## REMARKS

These amendments and remarks are in response to the Non-Final Office Action mailed April 20, 2004 in the above-captioned application. Claims 1-26 are pending in this application. Claims 14 and 15 were amended in a preliminary amendment filed June 30, 2003. Claims 1-20 have been allowed. Claims 21-26 have been rejected.

Fig.2  
<Prior Art>

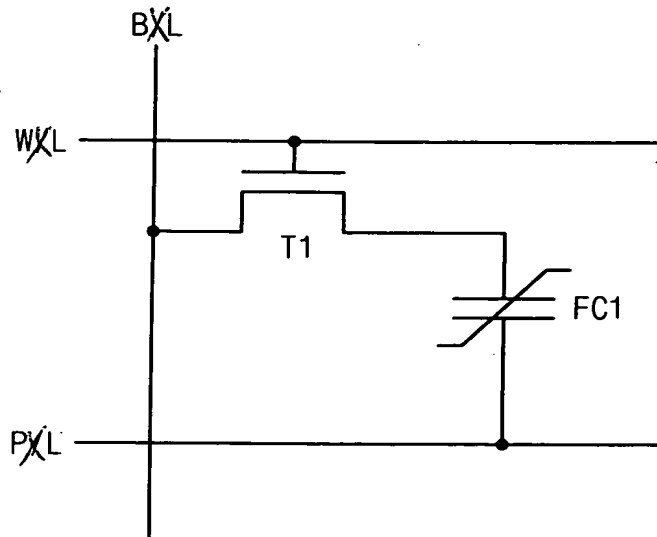
The Examiner objected to the drawings as failing to comply with 37 CFR § 1.84(p)(5) because the drawings including the reference signs not mentioned in the description. The reference signs objected to are identified by figure below. Applicants have amended the drawings and/or the specification in response to each objection as summarized below. Support for the amendments to the specification may be found in the corresponding figures or within the specification as discussed below.

Fig. 2 – B/L, W/L, and P/L: Applicants submit herewith a replacement drawing sheet wherein "B/L," "W/L," and "P/L" have been replaced with "BL," "WL," and "PL," respectively.
